Eastern Regional Power Committee

Sub: Minutes of the 139th PCC meeting held on 26.09.2024

MINUTES OF 139th PROTECTION COORDINATION SUB-COMMITTEE MEETING HELD ON 26.09.2024 AT 10:30 HRS THROUGH MS TEAMS

ITEM NO. B.2: Total Power failure at 220/132 kV Purnea (PG) S/s on 01.08.2024 at 15:50 Hrs

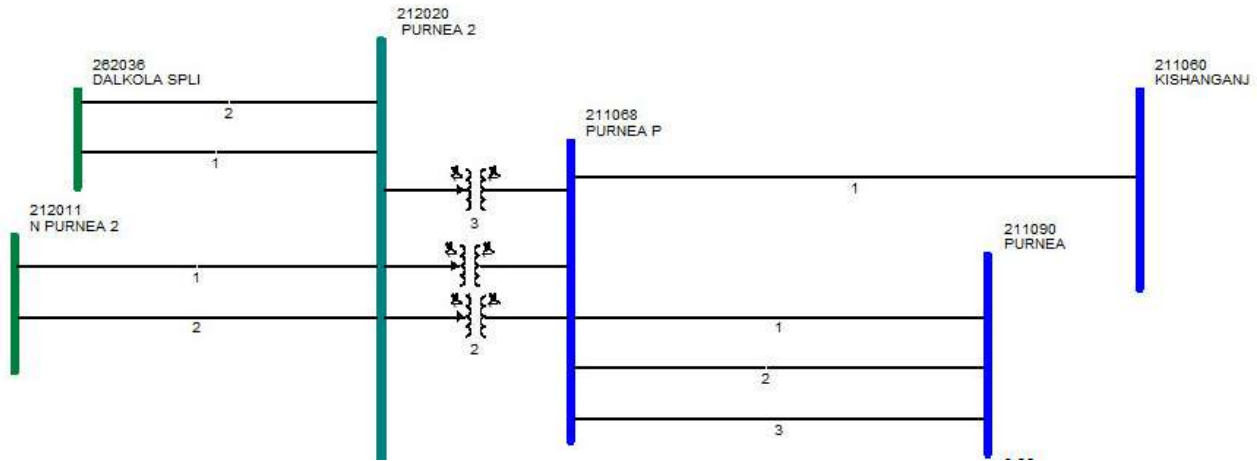
He informed that on 1st Aug 2024, various no. of faults was observed in downstream of 132 k V Purnea (BSPTCL)S/s between 15:40- 15:50 Hrs which were cleared however at 15:50 Hrs, B phase fault got developed in the downstream of 132 kV Purnea S/s which was not cleared.

He further added that after 350 ms of initiation of fault, 220 kV New Purnea-Purnea D/c tripped due to back Up O/c and E/f fault from New Purnea end.

After tripping of 220 kV New Purnea-Purnea D/c, 220 kV Gazole-Dalkhola D/c started feeding the fault through 220 kV Gazole-Dalkhola-Purnea link subsequently 132 kV Purnea-Purnea-2 & 3 tripped from PG end in Zone-3 after 1150 ms from New Purnea end however Back Up O/c and E/f protection also operated for 132 kV Purnea-Purnea- 3.

He further added that pickup for Backup O/C & E/F protection and Zone-3 protection was also observed for 132 kV Purnea-Purnea-1 however zone 3 protection got reset and hence no tripping was observed for this line due to which fault was still getting fed and it was cleared after tripping of 220kV Dalkhola- Gazole d/c from Gazole end in 1270 ms after initiation of fault.

ERLDC representative informed that 132 kV Purnea-Purnea-1 didn't trip from either end as in between Zone-3 dropped for around 120 msec and picked again however, Back Up O/c Picked at Purnea (Bihar) at 1060 ms from initiation of fault. Further, direction of B phase current also reversed at Purnea which shows that at this instance, fault developed in 132 kV Purnea-Purnea-1.

- *Regarding review of o/c e/f settings of 220 kV New Purnea-Purnea D/c with back up o/c settings of 220/132 k V ICTs, PG representative informed that the settings are reviewed and shared to site for implementation.*
- *Regarding operation/pickup of distance protection (as backup protection) for 132 kV Purnea-Purnea T/c instead of differential protection (as main protection), PG representative replied that even though the differential protection is in healthy state, all the zones (except Zone1) will operate as backup protection.*

- Regarding non operation of differential protection for 132 kV Purnea-Purnea-1, PG representative replied that differential protection will be tested during next opportunity shutdown.
- Regarding non time synchronization of DR of 132 kV Purnea-Purnea-3, PG representative informed that DR time synchronization had been completed.

PCC advised PG representative to test differential protection for 132 kV Purnea-Purnea-1 along with rectification. It further advised BSPTCL representative to test OPGW and differential protection for 132 kV Purnea-Purnea-1 along with rectification at their end.

PCC advised PG representative to share reviewed settings at Purnea (PG) with ERPC/ERLDC for their confirmation.

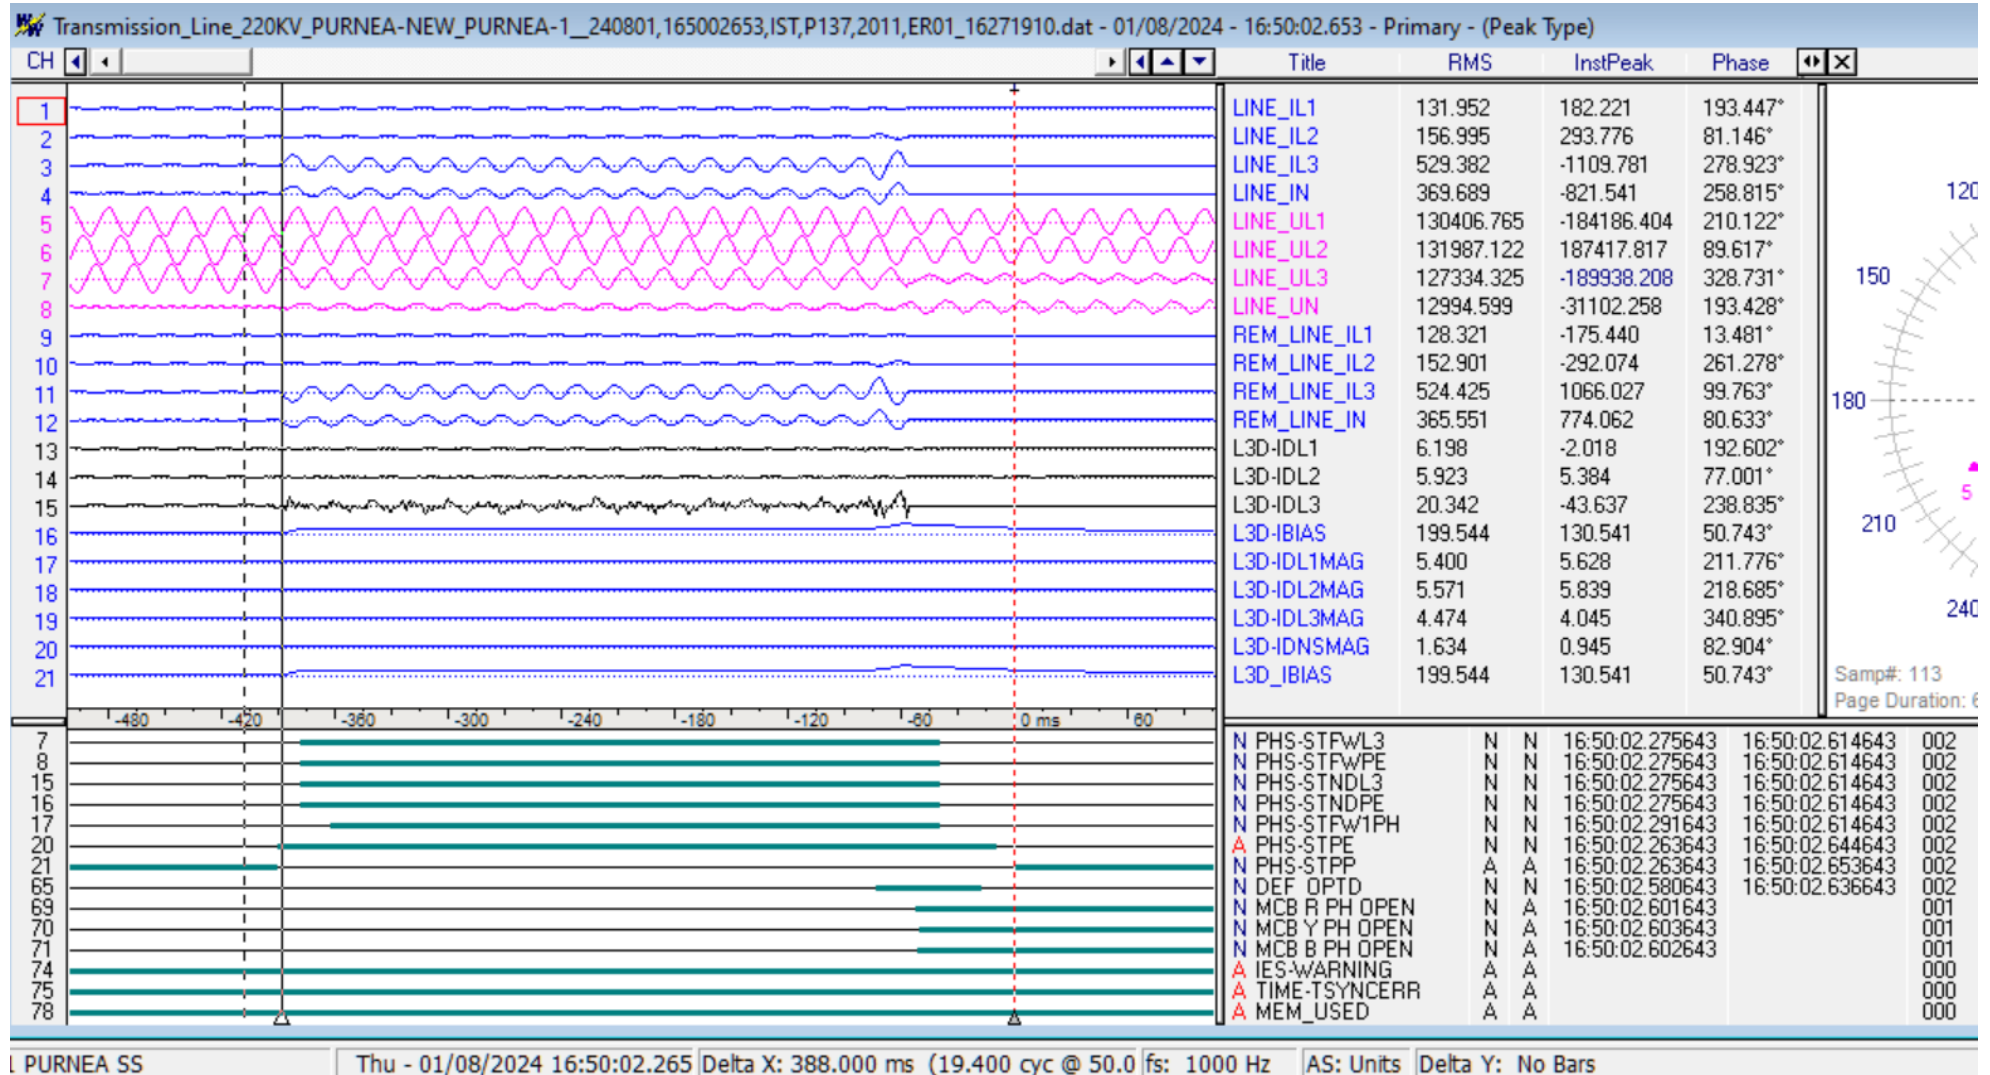
As information received from BSPTCL, actual fault was occurred in 33 kV downstream feeder of 132 kV Purnea (BSPTCL) End due uprooting of Pole and the fault was not cleared from their end.

Due to continues feeding of fault current from Upstream level i.e., 220kV Purnea, 220kV New Purnea and 220kV Gazole (WB) was operated by Backup Protections.

Review the settings of O/C and E/F Fault Protection in 132kV Purnea- Purnea (BSPTCL) feeders to operate in advance 220kV Purnea – New Purnea Feeders may be increased to provide the downstream level to clear the fault.

ERPC Observation	Action Plan
<p>Tripping of 220 kV New Purnea-Purnea D/c on back up O/c and E/f was not desirable. Its setting may be reviewed and co-ordinated with Back Up O/c setting of 220/132 kV ICTs. PG may review the settings.</p>	<p>The settings are reviewed and shared to site for implementation</p>
<p>132 kV Purnea-Purnea T/c have differential protection with distance protection as back up then distance protection should not have operated/picked up at Purnea (PG) end if differential protection was in healthy state. PG/BSPTCL may check and confirm.</p>	<p>Even though the differential protection is in healthy state, all the zones (except Zone1) will operate as B/U protection.</p>
<p>Differential protection didn't operate in 132 kV Purnea-Purnea-1. PG/BSPTCL may check and confirm.</p>	<p>Will be tested during next Opp SD</p>
<p>DR of 132 kV Purnea-Purnea-3 is not time synchronized at PG end. PG to take necessary action</p>	<p>Done</p>
